CANNON BEACH COMMUNITY DEVELOPMENT

MEMORANDUM

RE: Tree Removal Permit

264 E. Van Buren St., Taxlot 51029BC04800

TREE LOCATION SITE DIAGRAM

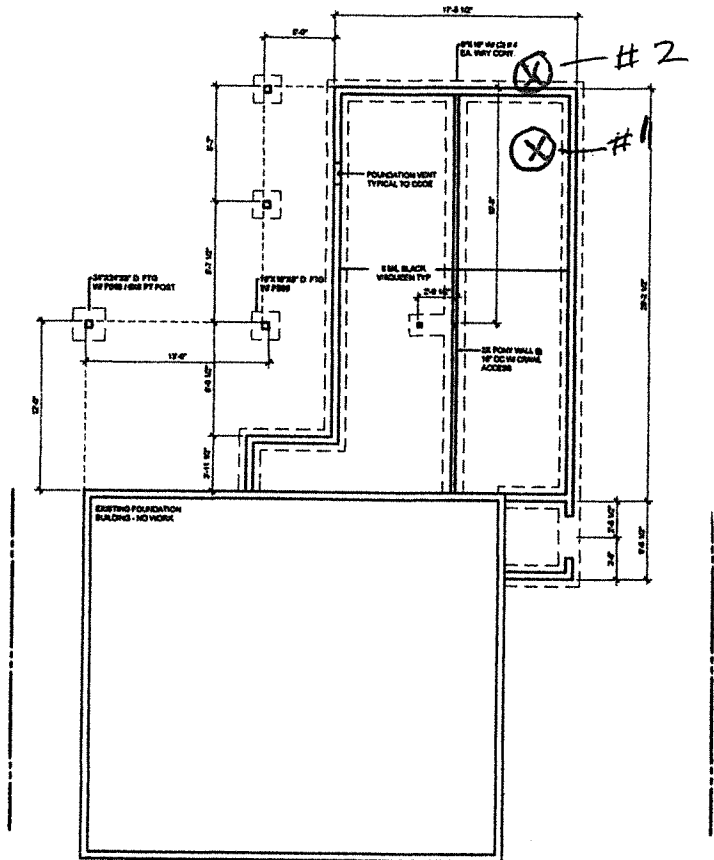
TREE # 1 LOCATED WITHIN PROPOSED BUILDING-ADDITION
 TREE # 2 LOCATED WITHIN 2' OF EXCAVATION. NOTED
 THAT 70% STRUCTURAL ROOTS WITHIN EXCAVATION,
 ALDER SPECIES DEVELOP DECAY WHEN ROOTS
 ARE IMPACTED. AVB

There is a proposed addition to the existing residence per the design provided by Vito Cerelli. As delineated by you from the building plan, the north side of the addition will clearly impact two Alder trees. (Refer to the attached Tree Location Site Diagram). Tree #1 is a 26" DBH Alder that is within the building envelope. Removal of this tree is necessitated to accommodate the proposed building addition.

Tree #2 is a 14" DBH Alder that is close to the building envelope with 70% of the tree structural roots in the excavation area. Root system disturbance to Alder always results in decay and tree failure. Removal of this tree is recommended.

An addition to the residence is planned at 264 E Van Buren. Two red alder (*Alnus rubra*) trees will be impacted by the planned design. The trees are 14" and 26" in diameter. I recommend the trees be given approval for removal based on Permit Criteria A: "*You are constructing a structure...*".

The replanting of 2 trees should be required. Consider smaller growing native trees for this site as space is limited.
